December 15, 2020

Reference: Response to Supplemental Peer Review Comments
Application for Site Plan Review, Case #9-20
150 Tihonet Road PV+ES Project
Wareham, Massachusetts
B+T Project No. 1833.112

RED PINE LANE - SIGHT LINE TO 150 TIHONET ROAD PROJECT

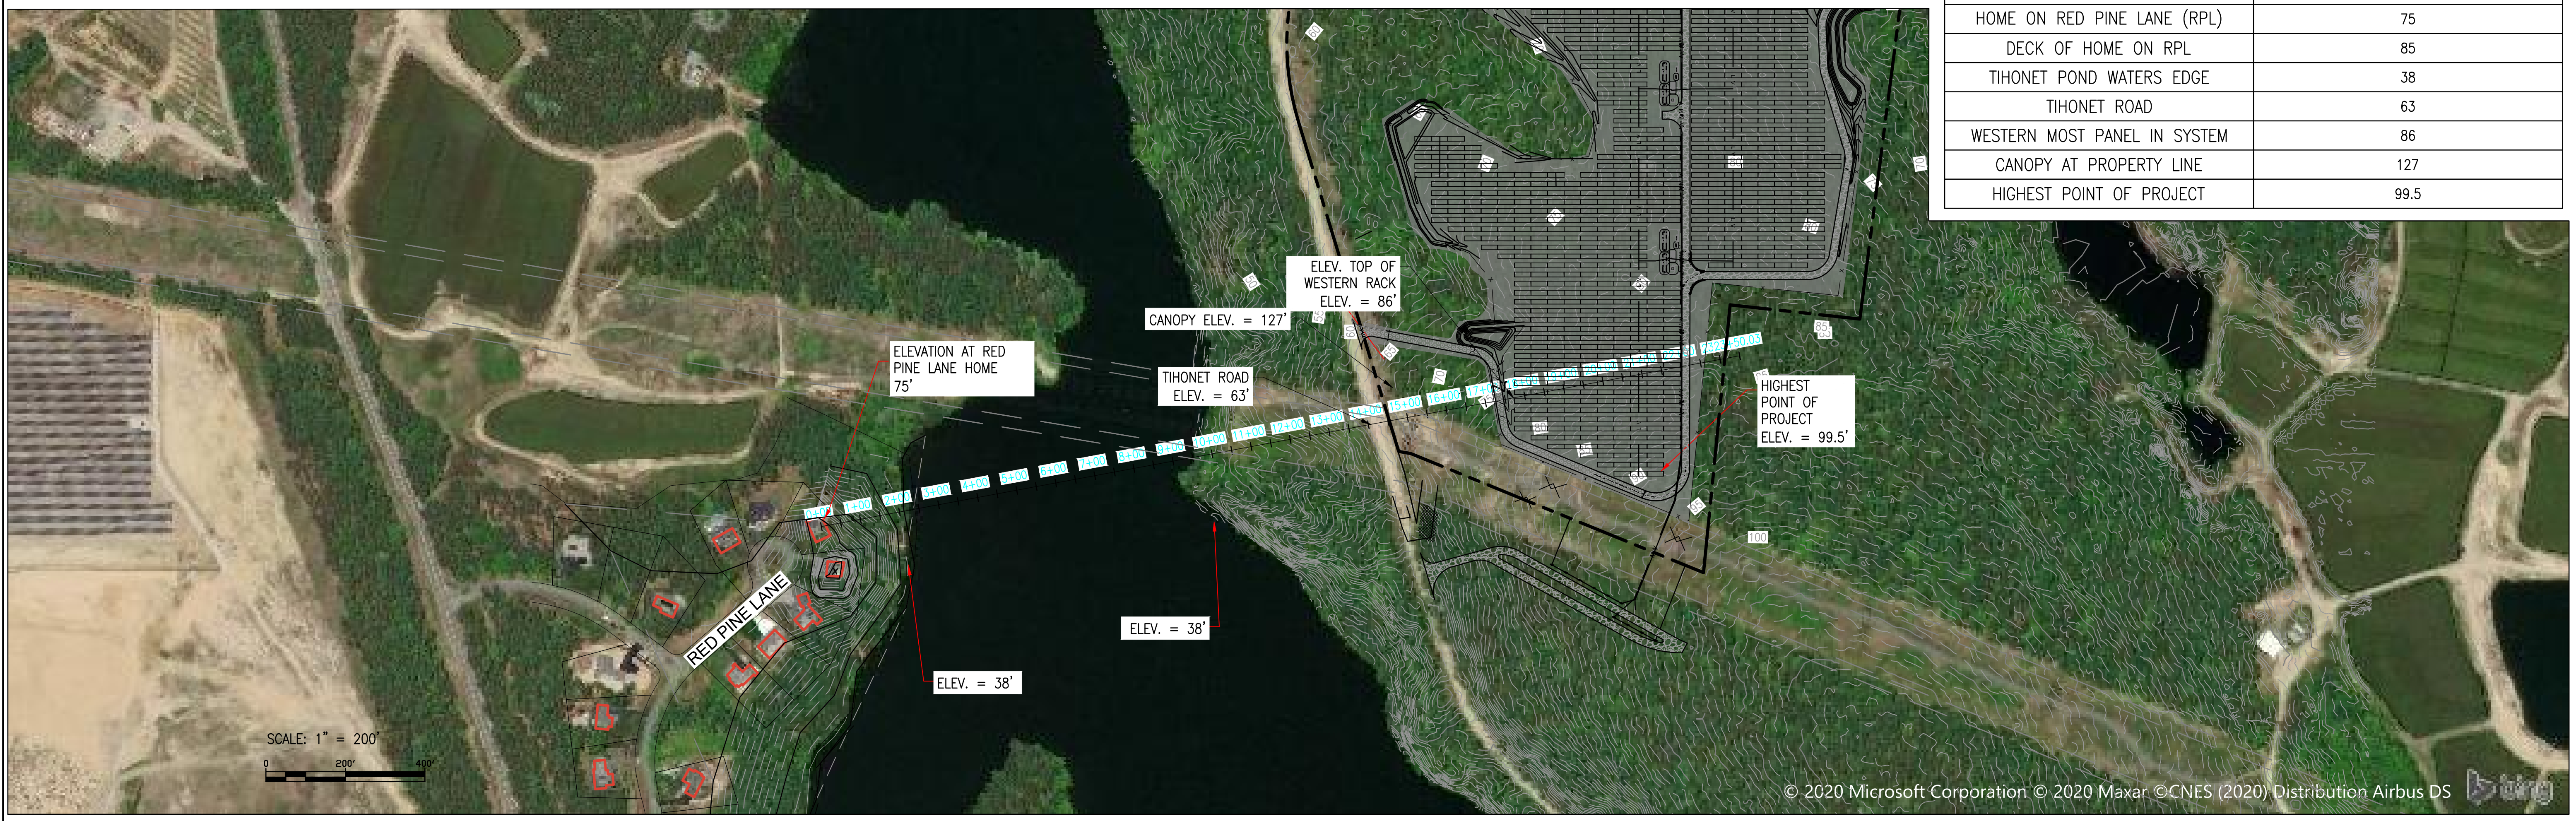
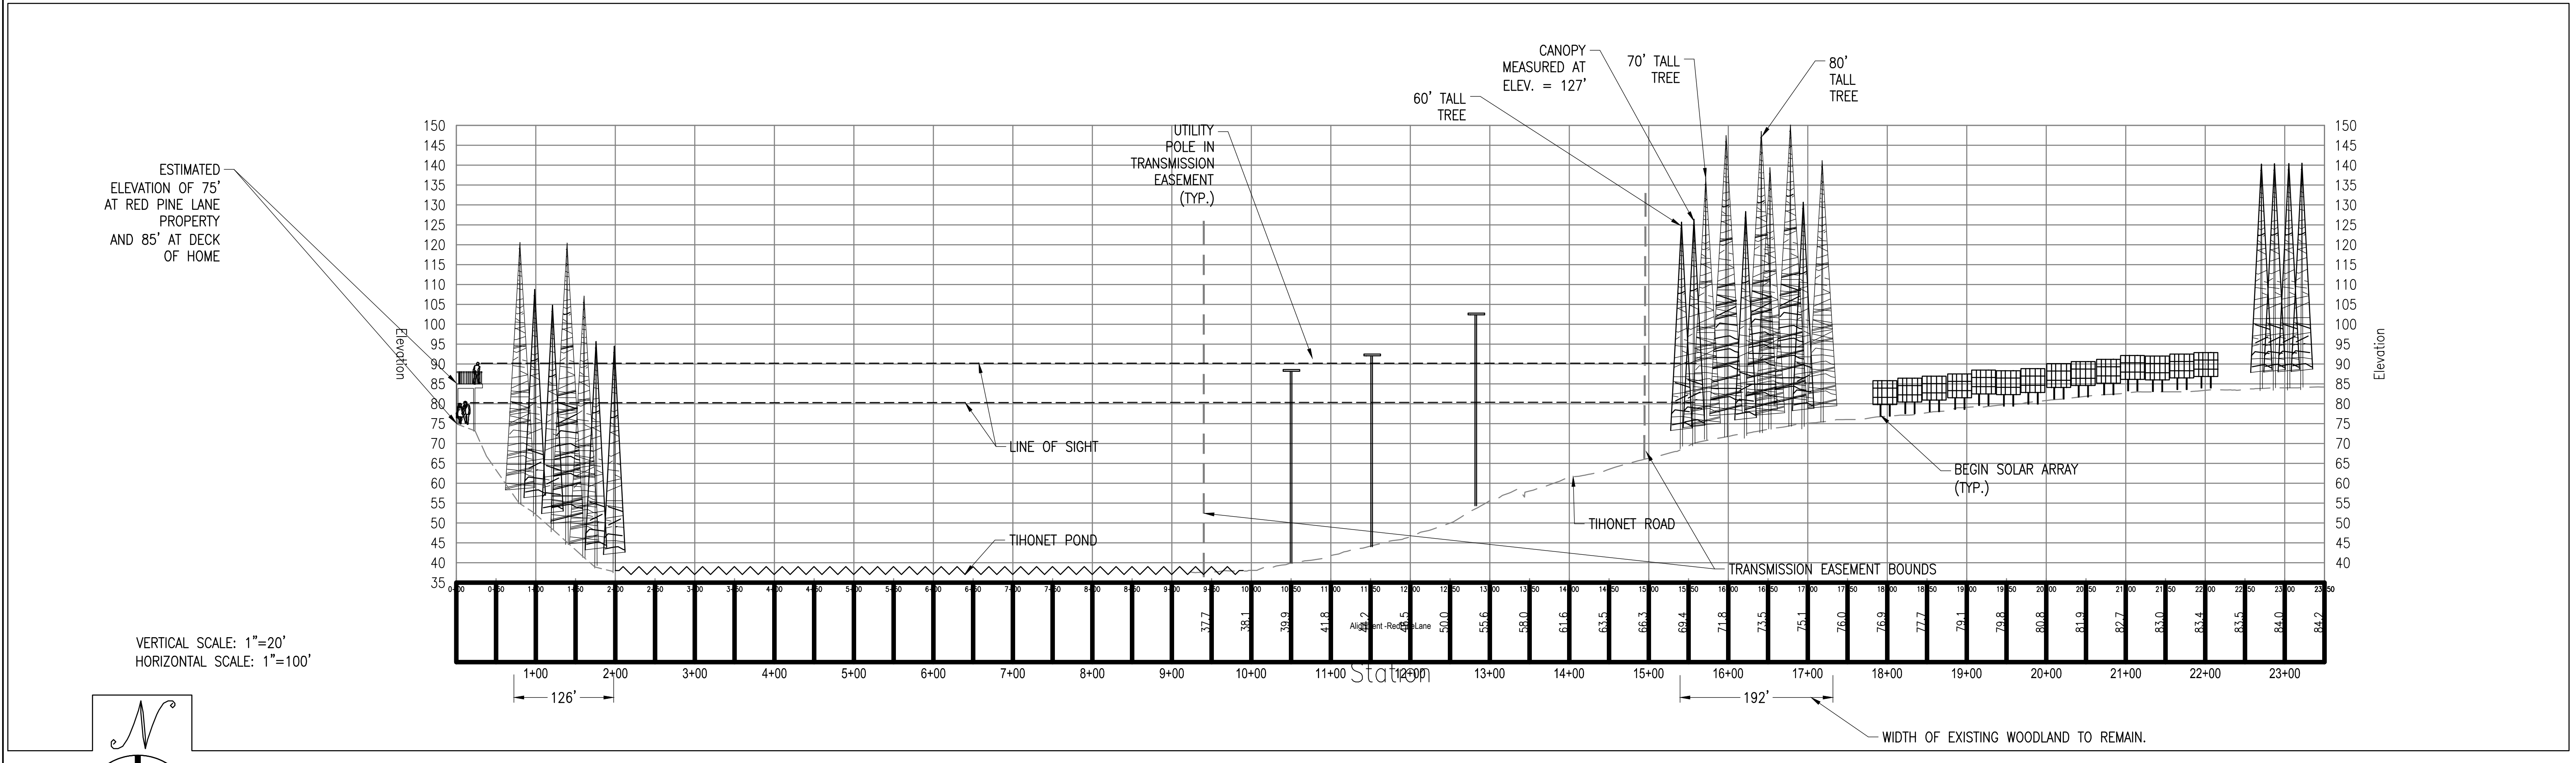
10. *The Sight Line Plan suggests that there will be a vegetated obstructed view of the solar array from Red Pine Lane. This assumes that once clearing is completed for the array area and the access road that runs parallel to the open transmission line easement that remaining trees will be dense enough cover left to act as an obstruction. This is questionable given that the cover left is only a small corner. It is recommended that the most southerly portion of the project area covering approximately 2.6 acres of the 50.69 acres be left in its natural state. (See Project Review letter dated Nov. 9, 2020) The maintenance of this small area with the current vegetation will greatly reduce the impact of the project on Red Pine Lane as well as from Tihonet Road. I recommend the plans be revised accordingly.*

The southerly entrance drive has been shifted north and the western extent of solar panels reduced in order to preserve additional wooded buffer. These adjustments to the design result in a mature vegetated buffer of approximately 192 feet from the existing tree line on the eastern side of Tihonet Road to limit of clearing.

When combined with (i) the approximately 126 feet of vegetated buffer from the residence on Red Pine Lane and the edge of Tihonet Pond, (ii) approximately 800 feet across Tihonet Pond, and (iii) another 500 feet through the utility's distribution and transmission corridor, we believe any potential impact to the viewshed from the Red Pine Lane residence has been nullified.

Please refer to enclosed profile view entitled "Red Pine Lane – Sight Line to 150 Tihonet Road Project" (revision date: December 11, 2020) for a detailed rendering of the approximately 1,800 feet between the residence in question and the project.
